***MAJOR PROJECT ASSESSMENT:  
Terminals Australia, Parkes  
Intermodal Terminal***

Director-General's  
Environmental Assessment Report  
Section 75I of the  
*Environmental Planning and Assessment  
Act 1979*

February 2007

**Figure 3:  
Heavy Vehicle Route**

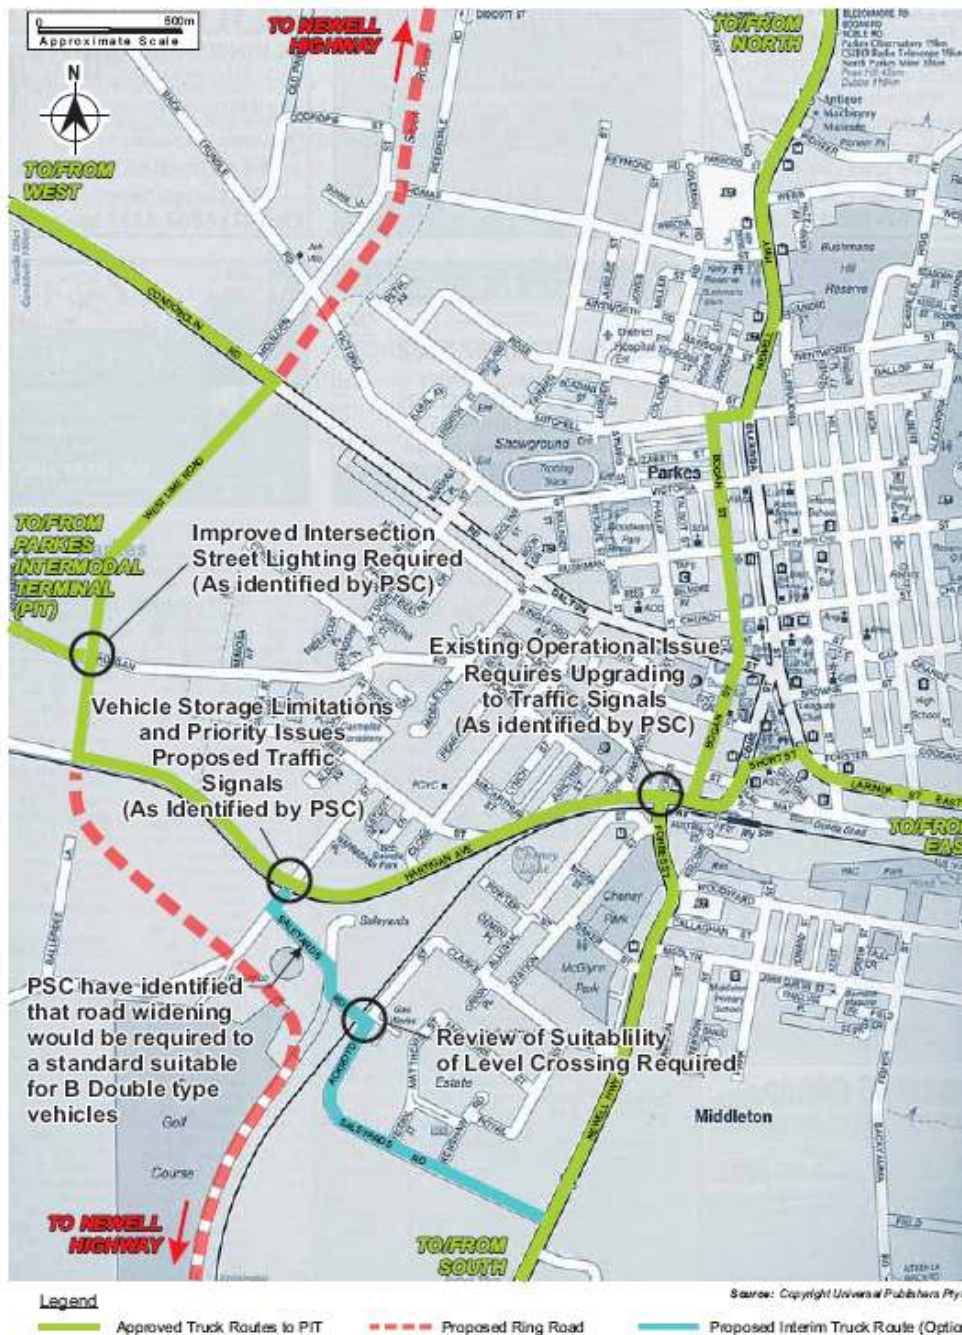
The majority of heavy vehicles would access the site from the Newell Highway via an approved truck route along Hartigan Avenue, West Lime Avenue and Brolgan Road, as outlined in Figure 3. A small number of heavy vehicles would also access the site via Condobolin Road.

Both the Proponent and RTA's modelling indicated that all rural and urban roads would perform at an acceptable level of service during the initial and ultimate stage of the development. Brolgan Road would be required to be upgraded, however, to adequately support heavy vehicles.

The Department therefore considers that the proposed roads along the truck route would adequately support traffic generated by the site, provided that Brolgan Road is appropriately upgraded to support heavy vehicles. As the Proponent and PS Marine Pty Ltd have already entered into agreement with Parkes Shire Council to upgrade Brolgan Road under the Auslink program, no further requirements are recommended by the Department.
